EILAR ASSOCIATES, INC.

Subject: Response to Acoustical Iteration Letter for Honey Hill Ranch, County of San Diego, STP 15-013

Honey Hill Ranch Condominiums / Units
Record ID: PDS2015-STP-15-013

Original Report: October 7, 2015
First Iteration: March 3, 2016

SHEET TITLE PLOT PLAN - PROPOSED CONDITIONS  
PROJECT HONEY HILL RANCH  
3087 HONEY HILL RANCH ROAD  
ALPINE, CA 91901

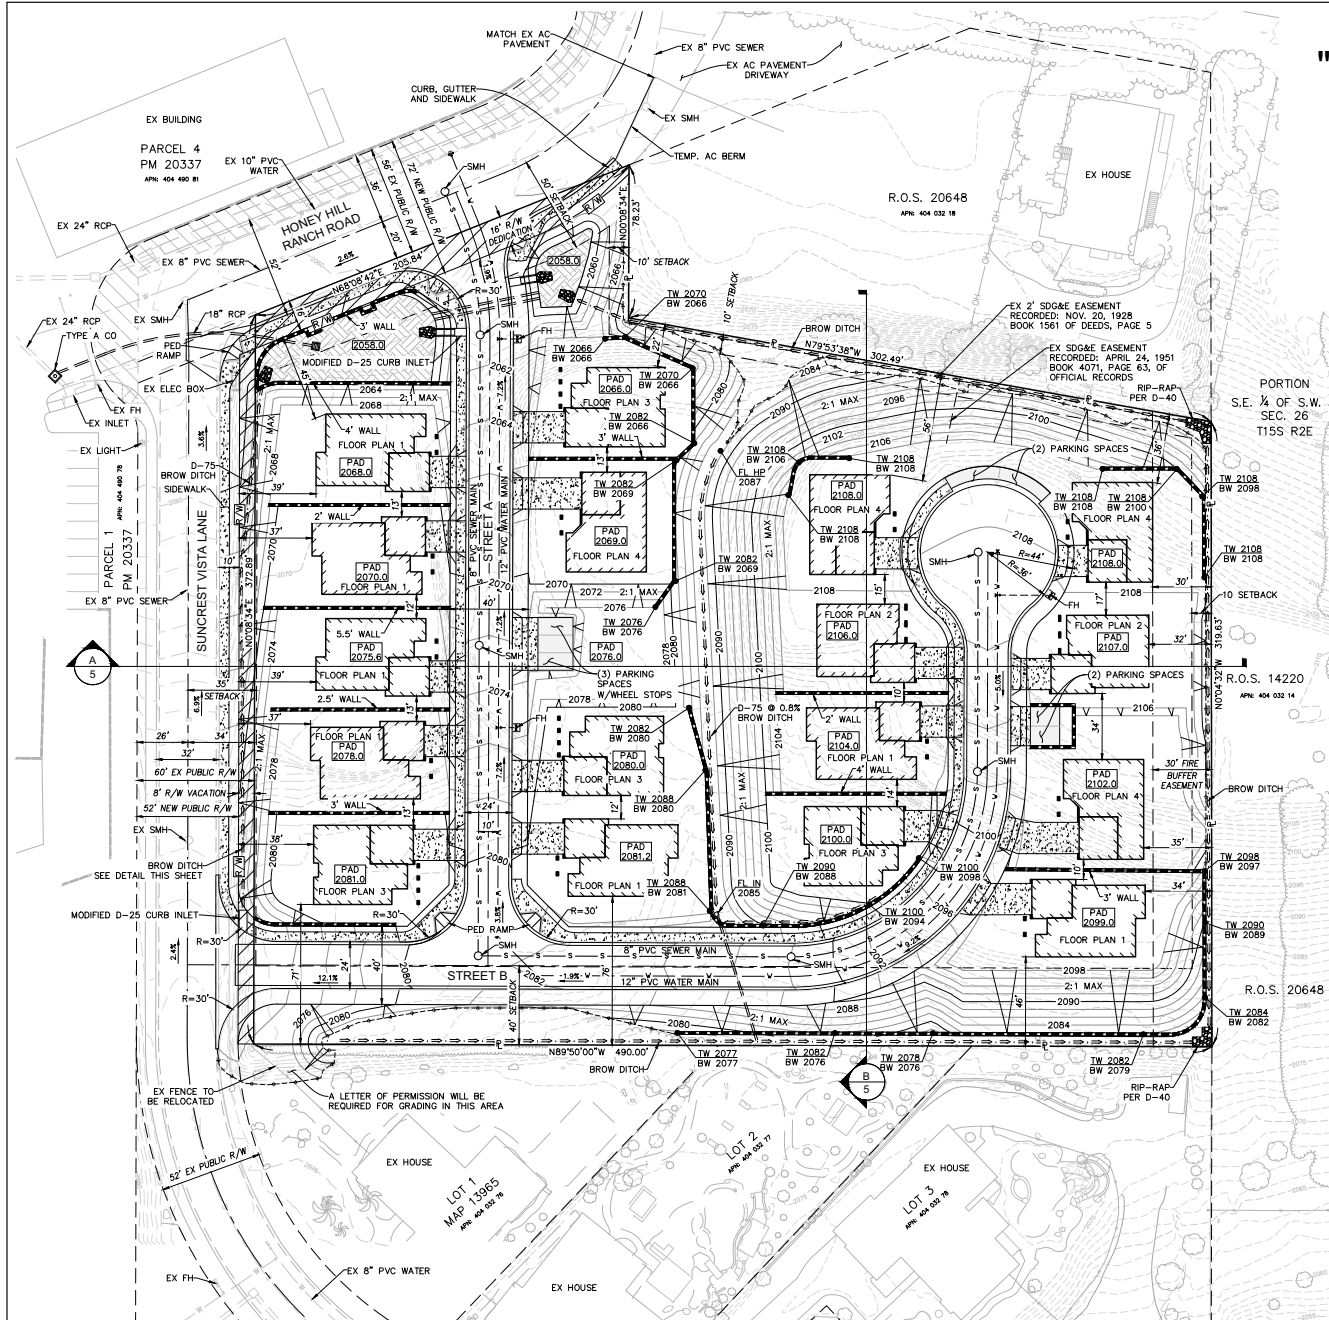
21-8: Please update site plans (plot plans) to show the noise reducing measures associated with the 6-foot high sound barriers. The plot plans (Sheet 3) shall be updated to reflect the recommendations on Figure 7 pursuant to the Noise Study.

RESPONSE: (No response required).
